SUBJECT: LASALLE COUNTY STATION, UNITS 1 AND 2 - ISSUANCE OF
AMENDMENT NOS. 250 AND 236 TO RENEWED FACILITY OPERATING
LICENSES RE: A LICENSE AMENDMENT TO TECHNICAL
SPECIFICATION 3.7.3, "ULTIMATE HEAT SINK (UHS)"
(EPID L-2020-LLA-0165)

3.7.3 Ultimate Heat Sink (UHS)

SAFETY EVALUATION BY THE OFFICE OF NUCLEAR REACTOR REGULATION

LASALLE COUNTY STATION, UNITS 1 AND 2

Figure 3.7.3-1 (page 1 of 1)
Temperature of Cooling Water Supplied to the Plant from the
CSCS Pond Versus Time of Day Requirements

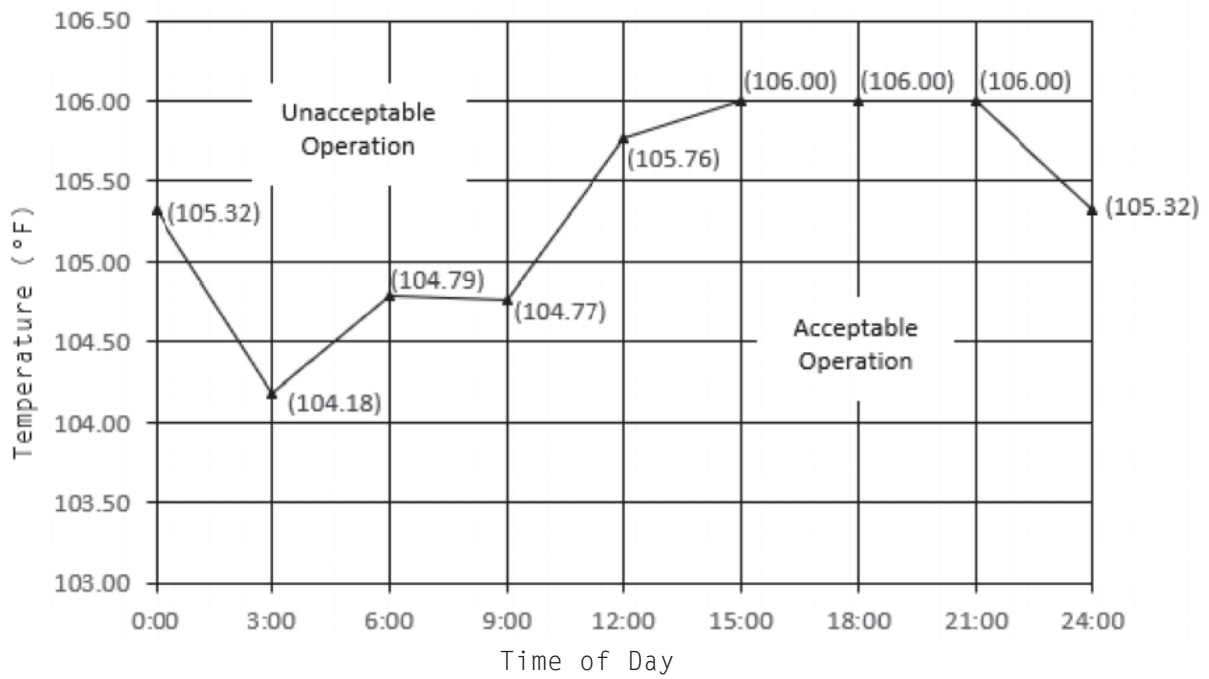
The amendments revised TS 3.7.3, "Ultimate Heat Sink (UHS)," for the LaSalle County Station, Units 1 and 2, to expand the TS temperature limit of the cooling water supplied to the plant from the UHS to vary with the diurnal cycle by changing the average sediment level limit in the UHS to ≤ 6 inches.

In the LAR, the licensee proposed a TS revision that would allow the UHS supply temperature when in Modes 1-3 to be dependent on the time of day (diurnally dependent) such that the peak post-accident water supply temperature does not exceed 107°F. The licensee has proposed a revision to TS 3.7.3 increasing the required TS temperature limit of the cooling water supplied to the plant from the UHS to vary with the diurnal cycle as shown in Figure 1 below from the blue curve to the red curve by changing the average sediment level limit from 1.5 feet to 6 inches. The blue curve represents the current TS requirements and the red curve is the LAR proposed temperature limits.

Figure 1 - Initial UHS temperature limits. (The bottom curve shows the current TS Figure 3.7.3-1 UHS temperature limits. The top curve shows the proposed TS Figure 3.7.3-1. UHS temperature limits)

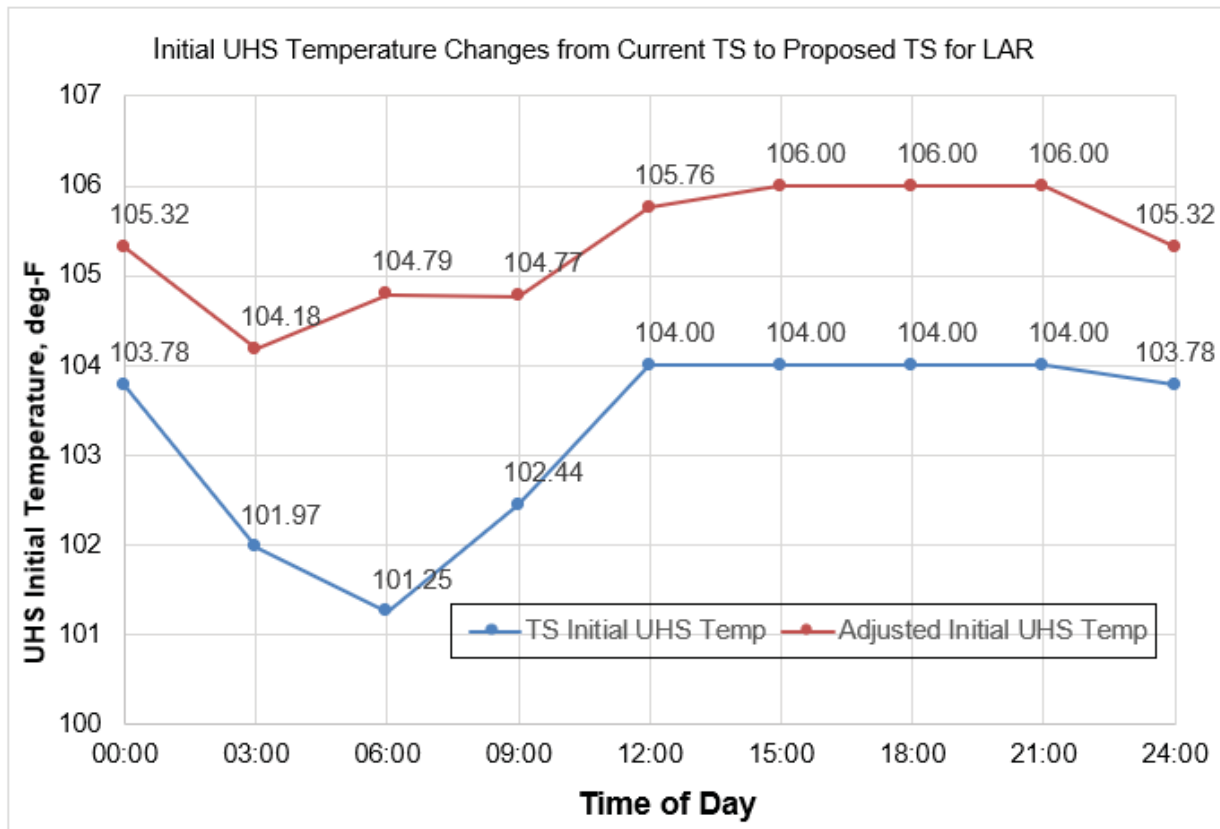
In the 2015 UHS SE, the NRC staff found acceptable the current LSCS TS Figure 3.7.3-1 (i.e., the lower curve in Figure 1 of this SE) of UHS temperature limit corresponding to the maximum sediment level of 1.5 ft. In Attachment 1, Section 7.1.5, of the LAR supplement dated October 22, 2020, the licensee performed a sensitivity study of UHS temperature under different sediment levels using its computer code LAKET-PC. The analysis incorporated the weather conditions from January 1995 to September 2010 from LSCS and analyzed the UHS design

The licensee adjusted UHS temperature corresponding to the average sediment level of 6 inches to obtain the proposed TS Figure 3.7.3-1 (i.e., the upper red curve in Figure 1 of this SE) using the following expression:

In light of the results of the NRC staff's confirmatory analysis and the conservatisms discussed above, the NRC staff determined that the proposed TS Figure 3.7.3-1 for UHS temperature TS limit is acceptable. Therefore, the NRC staff finds that the requirement of 10 CFR 50.36(c)(2) for LCOs is satisfied by TS LCO 3.7.3 and the TS limit of proposed TS Figure 3.7.3-1. Should
